**Origination Form**  
Proposed Revisions to a Standard Plans Index

<b>Originator:</b>	Exposito-Ferree, Amanda	<b>Index Number:</b>	440-001
<b>Date:</b>	6/3/2025	<b>Sheet Number(s):</b>	All
<b>E-mail:</b>	Amanda.Exposito-Ferree@dot.state.fl.us	<b>Index Title:</b>	Underdrain

Add an underdrain detail for wet detention side bank filters. Similar to current Underdrain Va but along a wet pond. To give designers another tool to meet the new ERP stormwater quality standards.

ADDED:  
Type Va (WET) Assembly

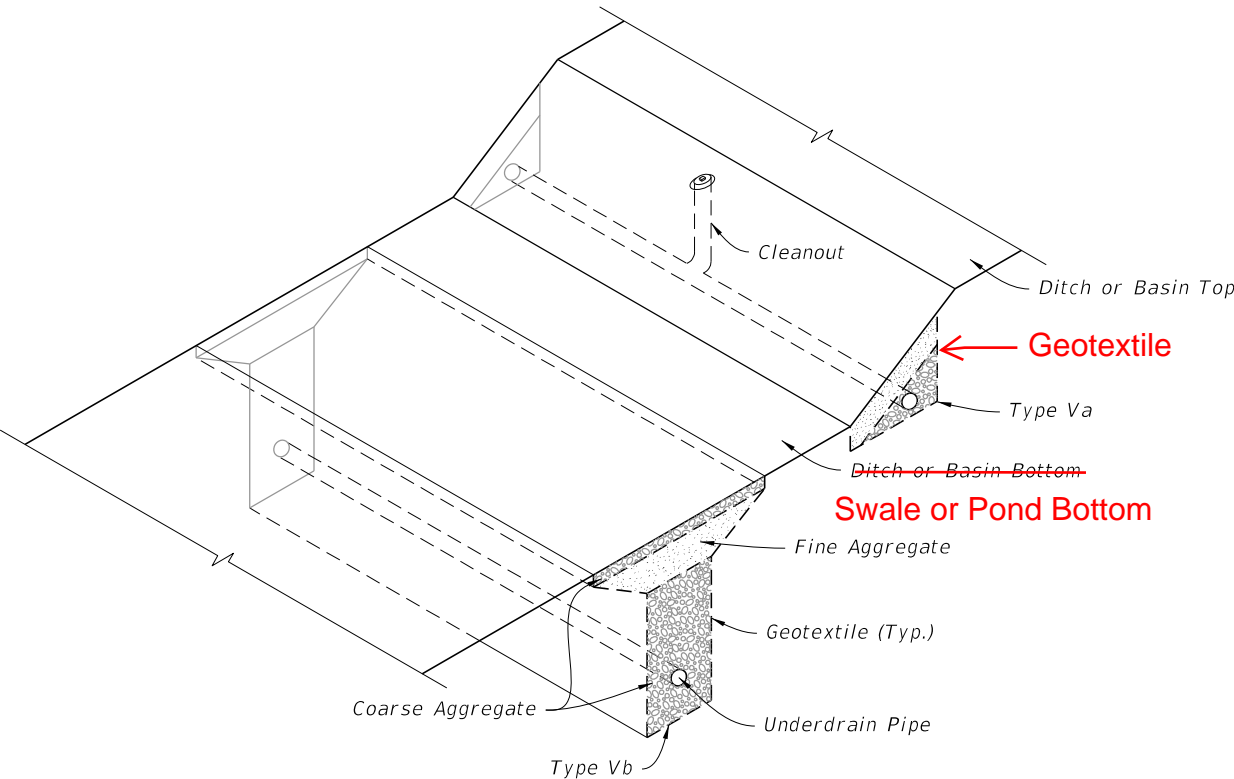
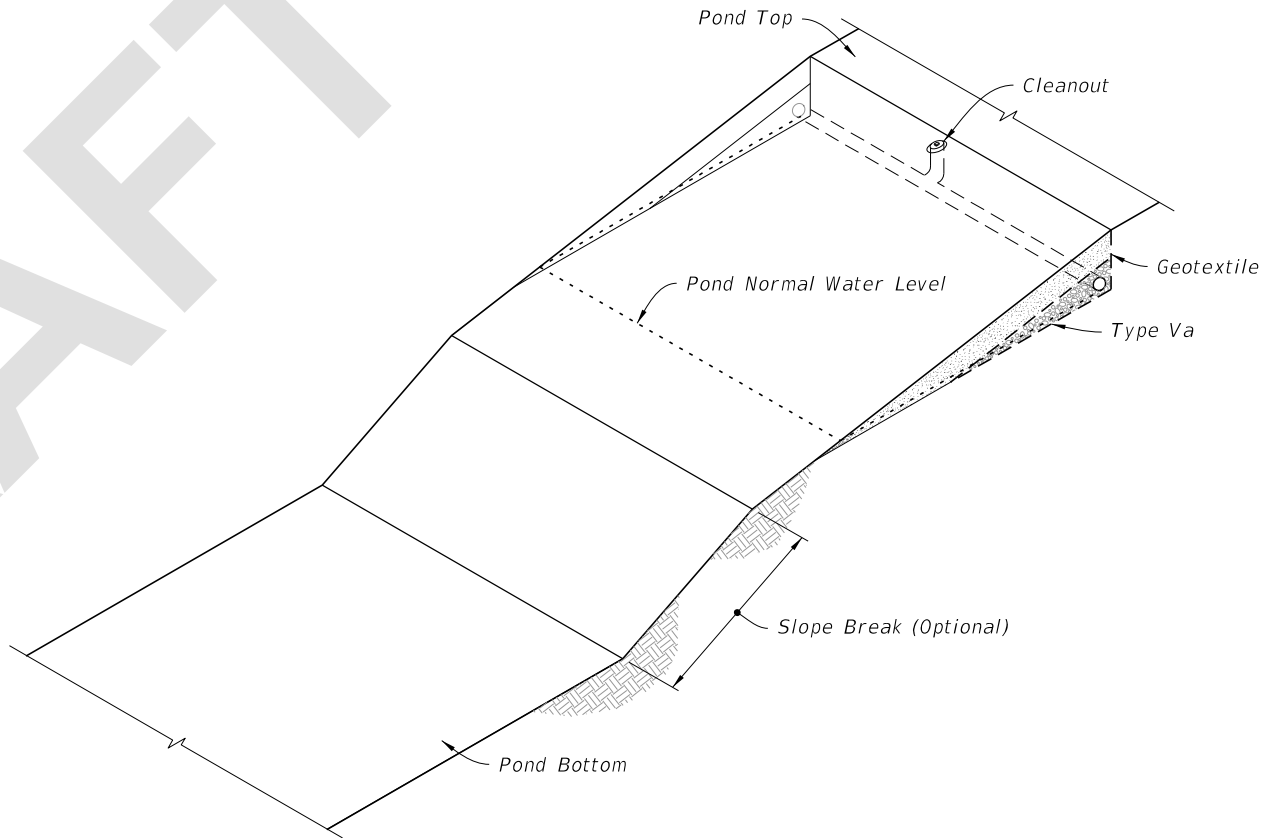
Sheet 1: Added General Note 10 "Pin the geotextile with soil or coarse aggregate at a minimum of 6"; Added TYPE Va (WET) ASSEMBLY; Added New Sheet to the Table of Contents.

ADDED NOTE 10:  
Anchor an additional 6" length of geotextile under soil or coarse aggregate as shown.

10. Anchor an additional 6" length of geotextile under soil or coarse aggregate as shown.

NEW SHEET 4

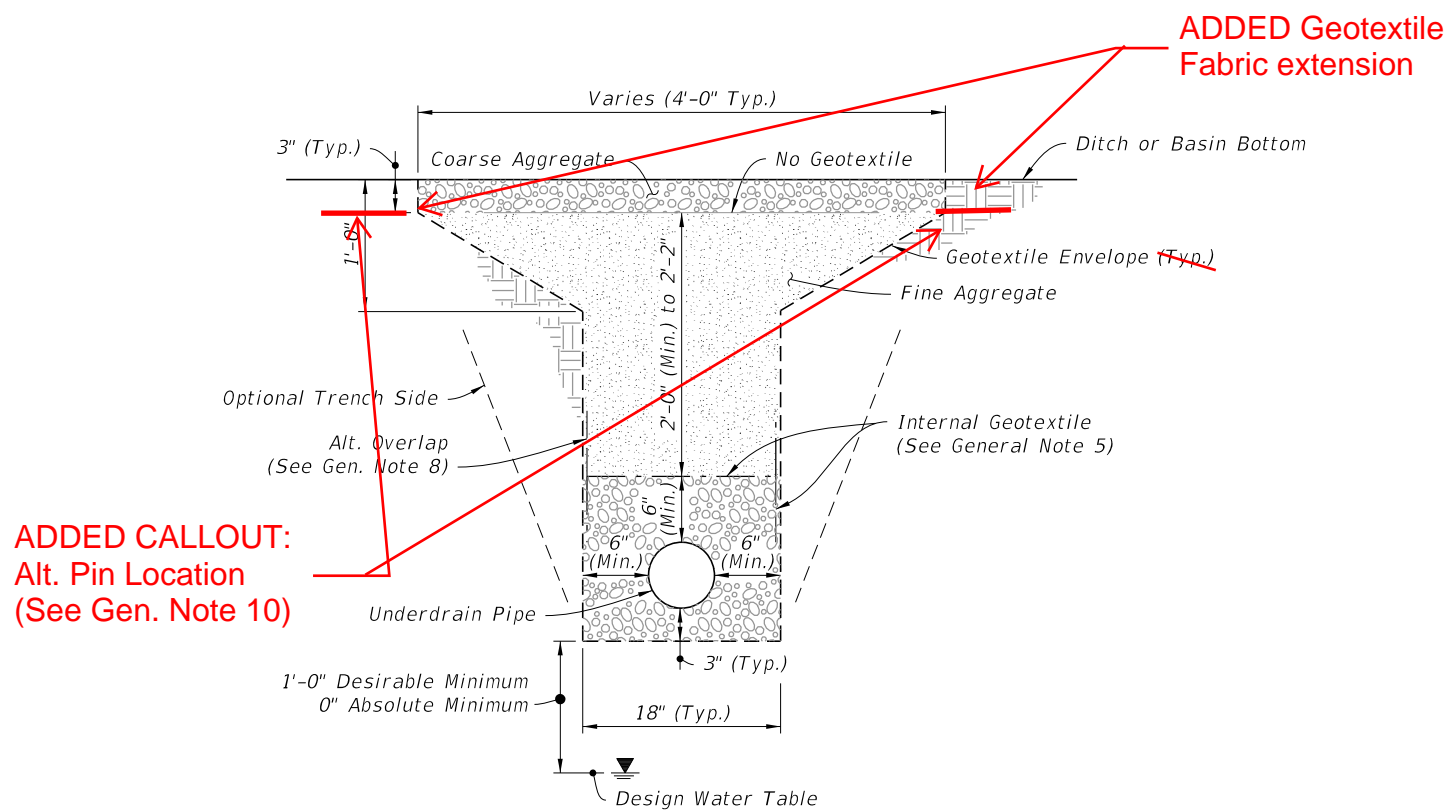
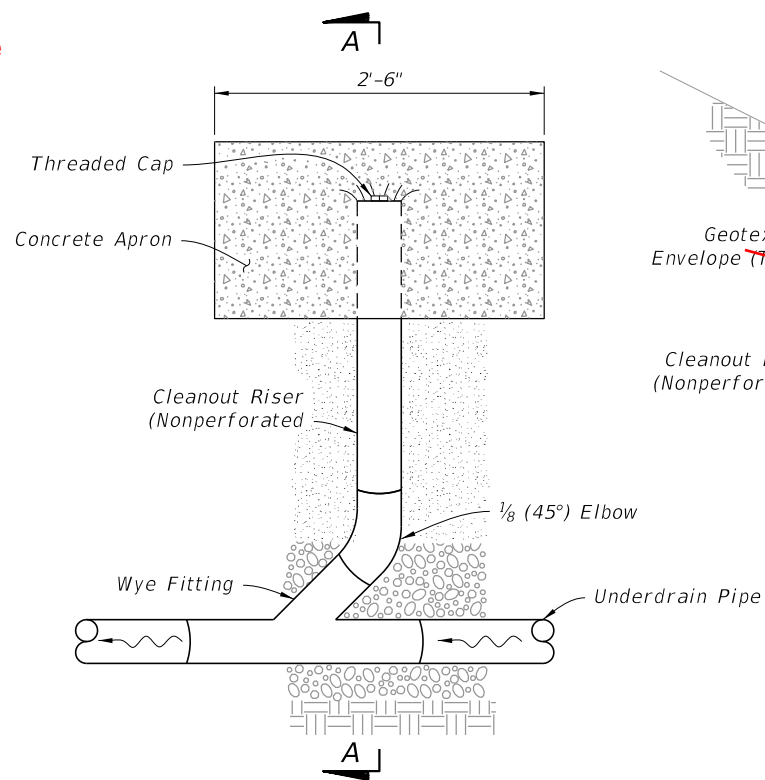
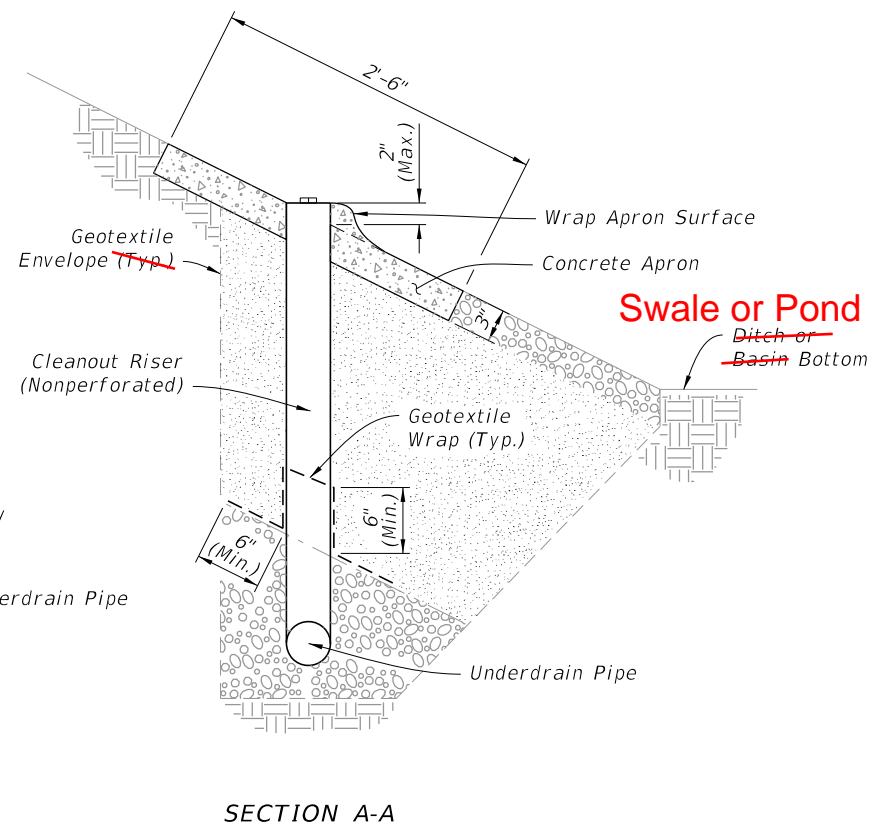
Sheet 3: Added Alt. Anchor Locations and Added Geotextile Extensions to the details; Renamed UPPER LIMITS details to "UPPER LIMISTS - DRY"; Added new detail for the UPPER LIMITS - WET; Moved TYPE Vb AND TYPE V CLEANOUT details to new Sheet 4; Changed "Ditch or Basin Bottom" to "Swale or Pond Bottom"

Sheet 4: Added Alt. Anchor Locations and Added Geotextile Extensions to the TYPE Vb details; Changed "Ditch or Basin Bottom" to "Swale or Pond Bottom"
